Submit an updated drainage report meeting current criteria

## FINAL DRAINAGE REPORT

## FALCON ACRES SUBDIVISION

JPS Project No. 020506

**D1**

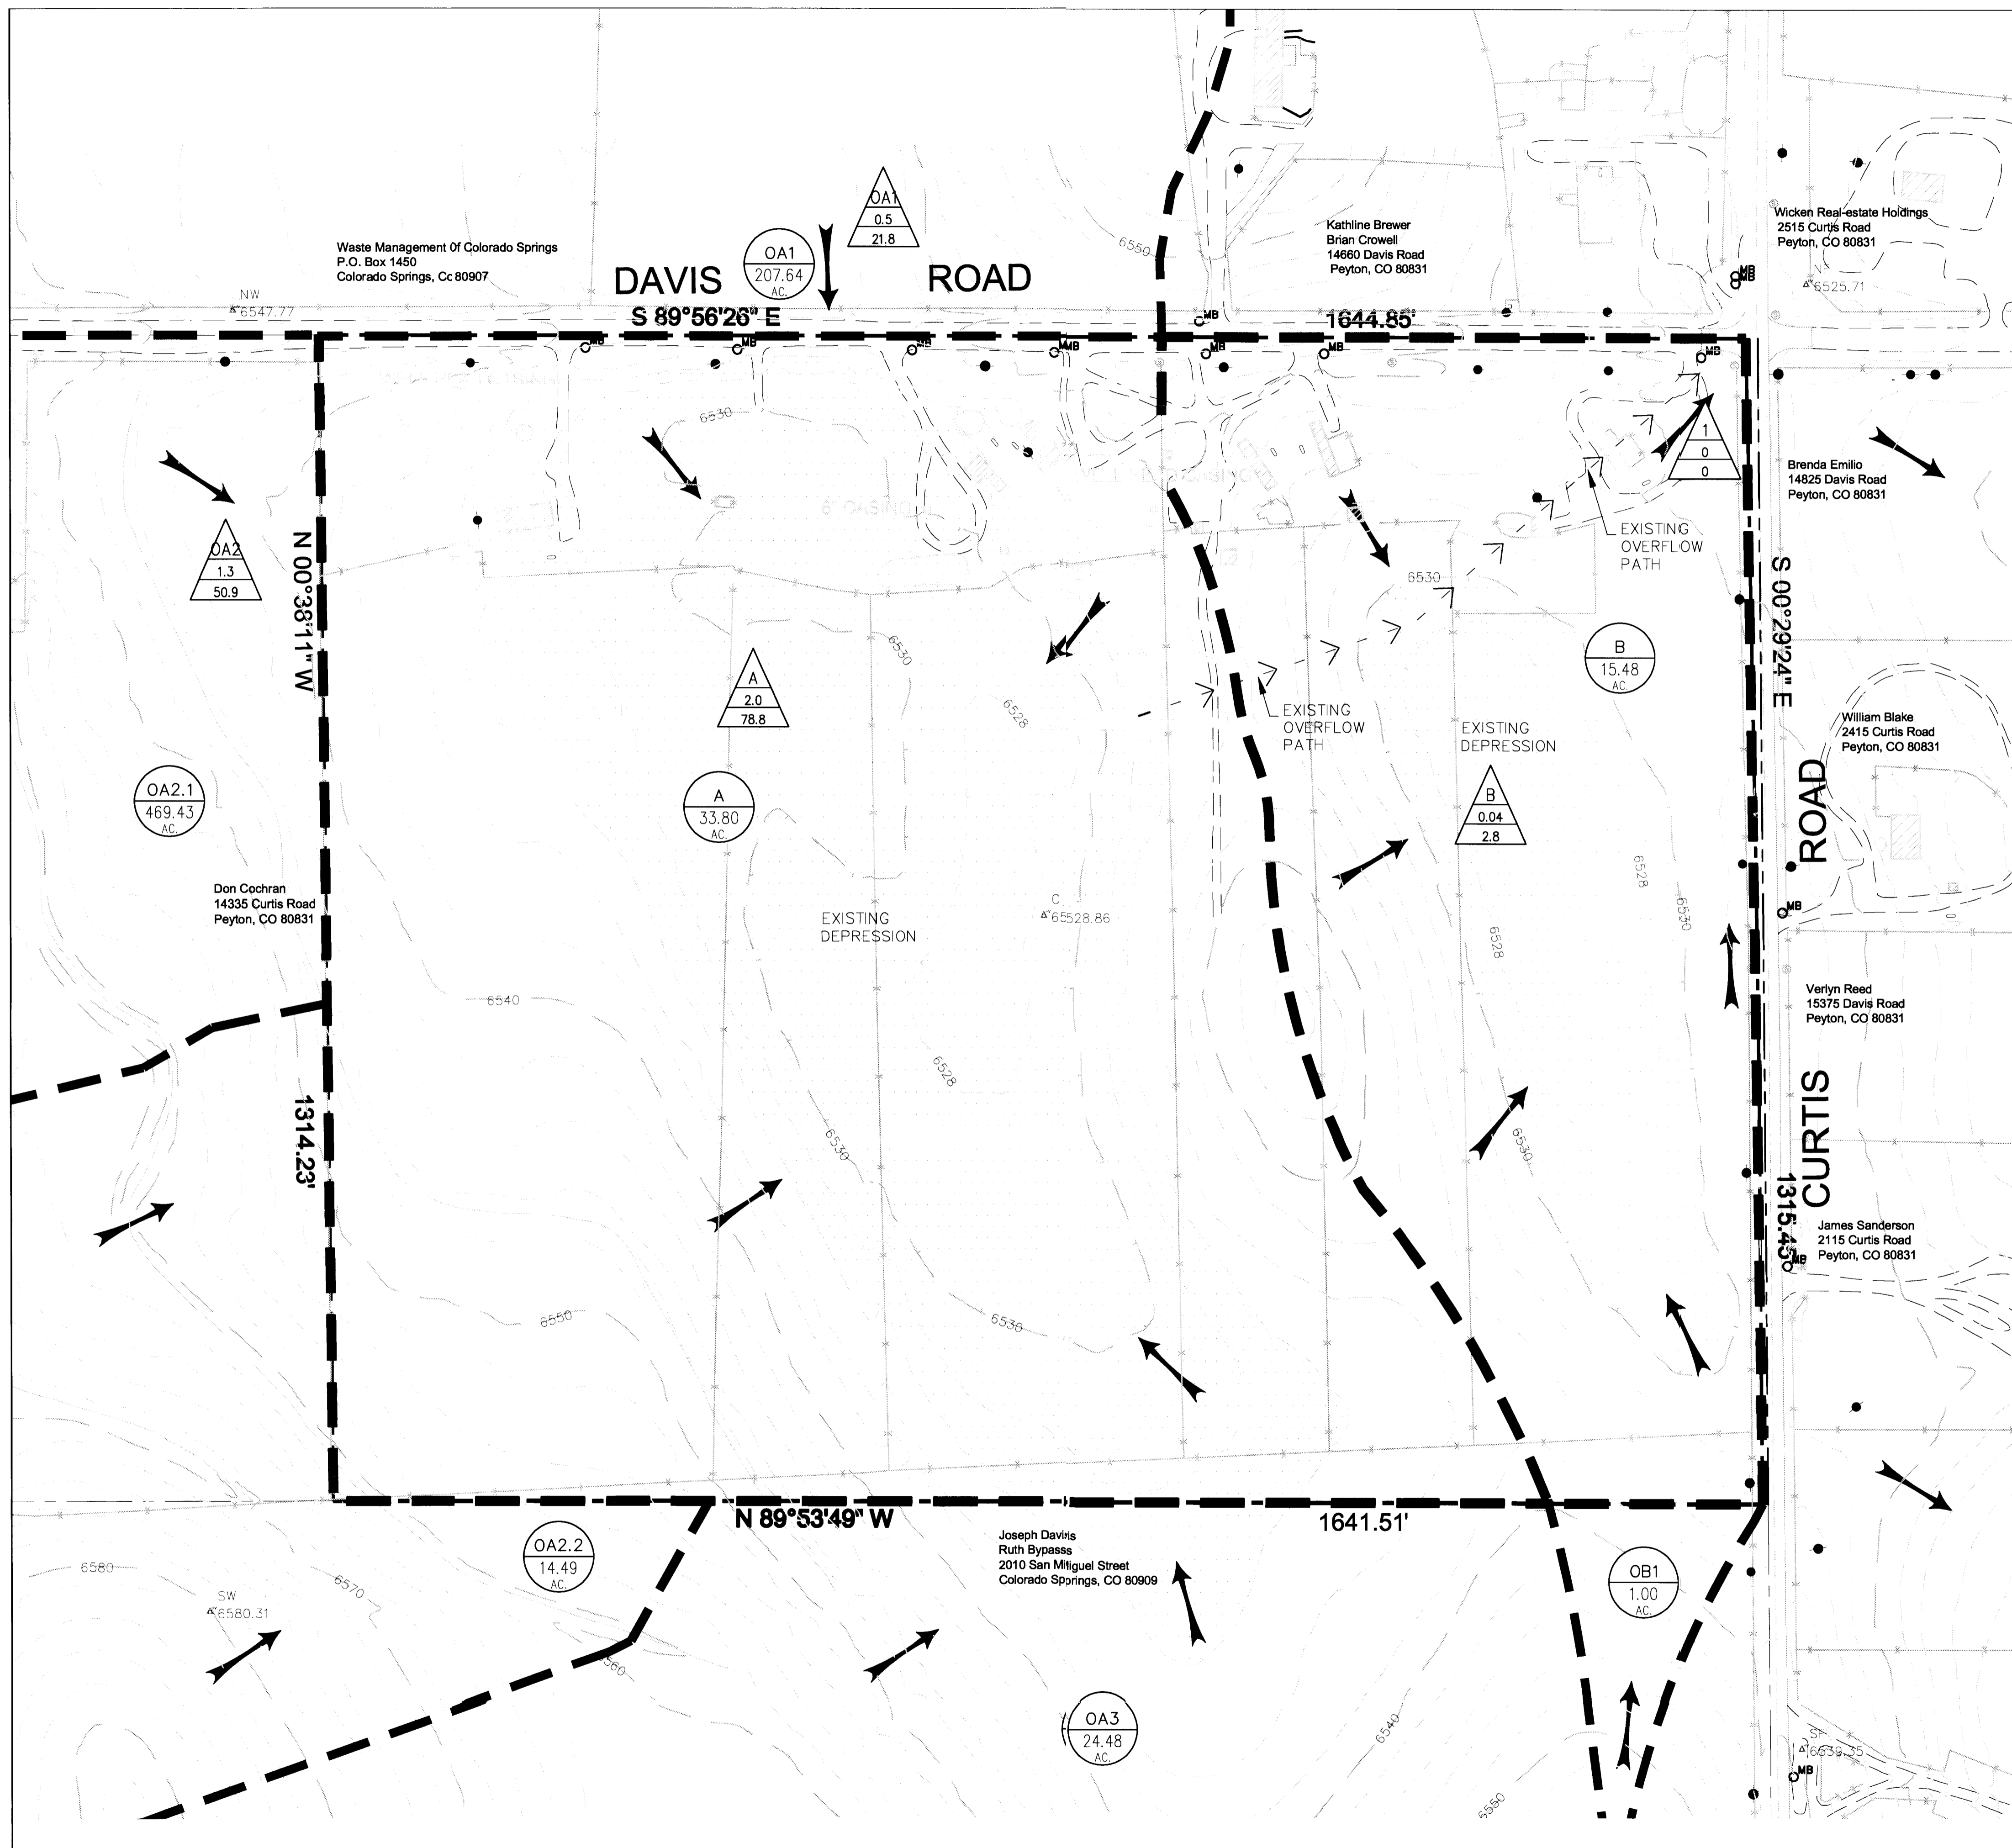
Upload a clearer drainage map. Unable to see the minor contours.

Updated.
